LINCOLN CITY/LANCASTER COUNTY PLANNING STAFF REPORT

for March 16, 2005 PLANNING COMMISSION MEETING

P.A.S.: Special Permit No. 05009, Fieldstone Center

PROPOSAL: To obtain a special permit for a community unit plan with 70 dwelling units.

FIELDSTONE C.U.P.

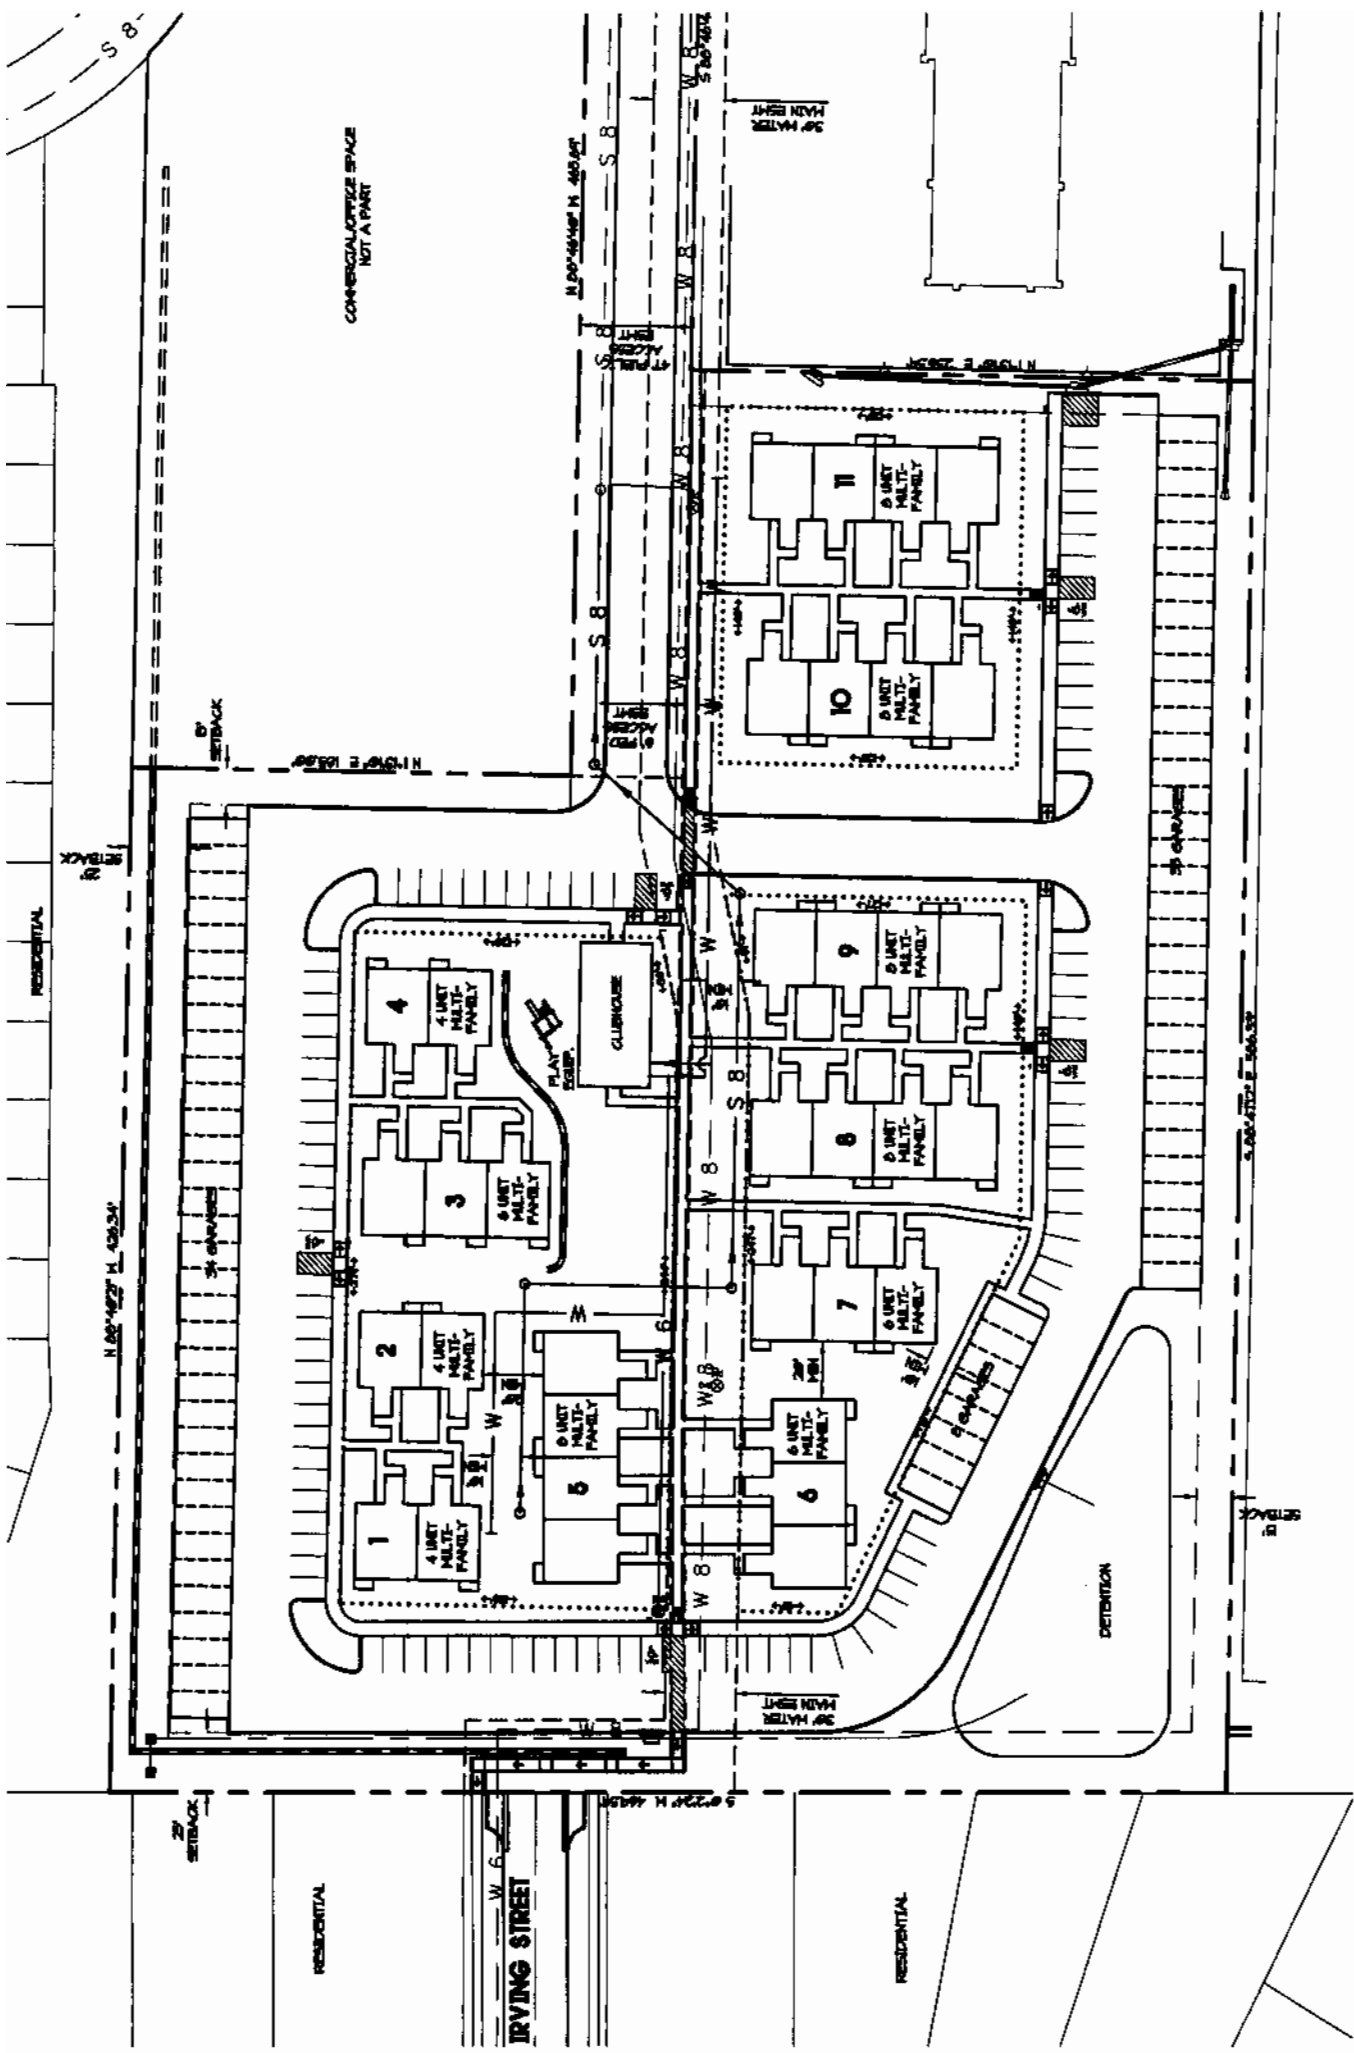
(1.1) The sewer along the driveway west of North 26th Street was originally shown as private. It has since been taken over as a public sewer. All new sewers to be built will be regarded as a private service. The required easement needs to be shown for the portion of the sewer that is public.

(3.1) Some assumptions within the detention calculations do not appear to be given the existing and proposed conditions. The proposed curve numbers seem too low for a town home use and the existing time of concentrations seem too high for open, undeveloped ground. The calculations must be documented or revised to the satisfaction of Public Works.

(3.2) The grading shown for the detention cell is unsatisfactory. A 2% minimum slope is required across the floor of the detention cell as per design standards. Revisions need to be made accordingly while maintaining the required volume.

(3.3) There is a portion of the site that drains to the south east to what appears to be an existing private storm sewer. Detention will need to be provided for this area unless it can be that detention was previously provided.

(4.1) A second access will need to be provided to this site since a single access is shown to serve in excess more than 40 units.

(4.2) The 47' common access driveway is presently platted as a private road for its frontage of the Baymont Inn lot. Eliminating the private road needs to be part of the approval of this CUP.

Upon review of CZ # 05017 and CUP/PUD # 05009 and the number of garages and dwelling units, we would request a couple of additional hydrants, one on the Northeast corner of building 4 and one on the Southeast corner of building 9. This would give us accessibility to a water supply if needed. Thanks.

Comments: **need additional site fire hydrants can not exceed 420 ft spacing.**

- 2.1.1 A revised site plan including 5 copies showing the following revisions:
 - 2.1.1.1 Show and dedicate a second access easement to the CUP site to the satisfaction of the Planning Department.

- 2.1.1.2 Show utility easements requested by the LES memo dated February 28, 2005.
 - 2.1.1.3 Sidewalks along the north side of the access drive into the property.

- 2.1.1.4 Show revisions to the satisfaction of the Public Works and Utilities Department memo dated March 2, 2005.
 - 2.1.1.5 Show revisions to the satisfaction of the Parks Department memo dated February 27, 2005.

- 2.1.1.6 Show fire hydrants to the satisfaction of the Fire Department and Building and Safety Fire Prevention/Life Safety Code.
 - 2.1.1.7 Reduce the curb radius to 20' near buildings 1 and 4.
